Status: Y  N  U **Seismic Walkdown Checklist (SWC) SWEL1-054**Equipment ID No. 0023CRFEquip. Class<sup>1</sup> 10Equipment Description CONTAINMENT RECIRC FAN 23Location: Bldg. VCFloor El. 68'-0"

Seismic Walkdown Checklist (SWC) SWEL1-054

**Note:** *Steel face for the fan in HEPA filter room with missing bolts*

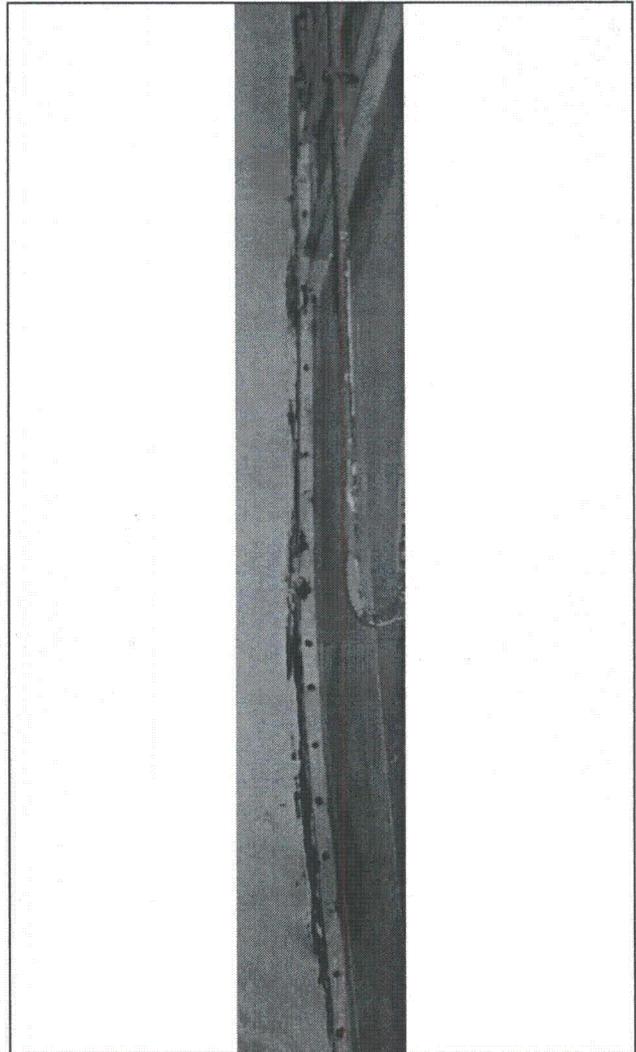
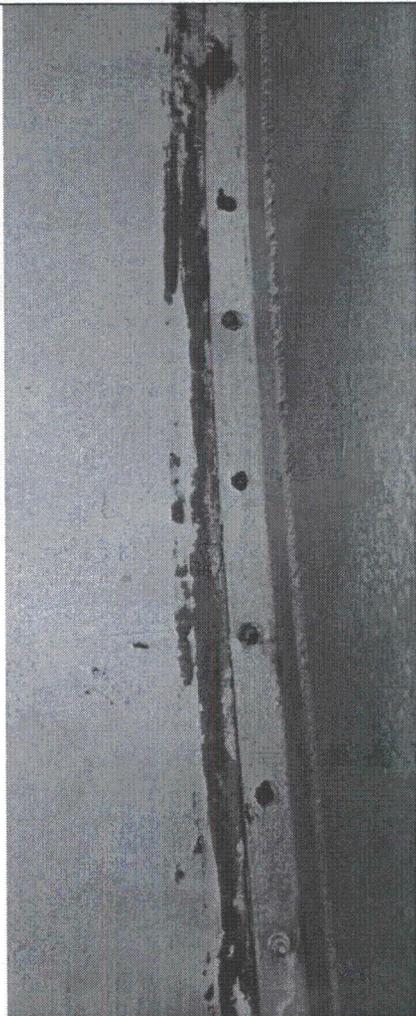
*Anchorage for all compartments are OK. Intend plenum anchorage for the fan in HEPA filter room has only 13 bolts out of 28 bolt holes. One of the remaining bolts is slightly bent. A comparison with 23CRF shows that original design has 16 bolts. CR-IP2-2014-01662 has been generated to address this condition. LB-17 assessed this condition and determined that the remaining bolts are adequate.*

**Note:** Flange on 22EDG JW & LO Coolers cooling WTR outlet with flush nut and showing minor surface corrosion.

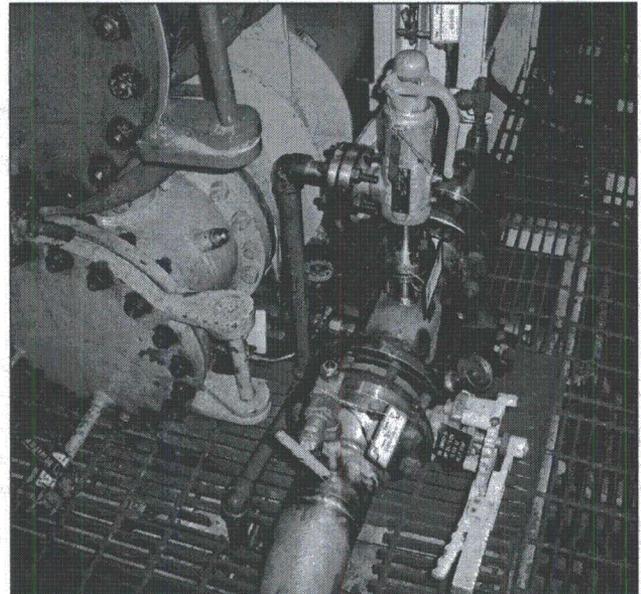
**Note:** Minor surface corrosion on flange couplings. Possible galvanic corrosion stainless steel pipe and carbon steel bolts.
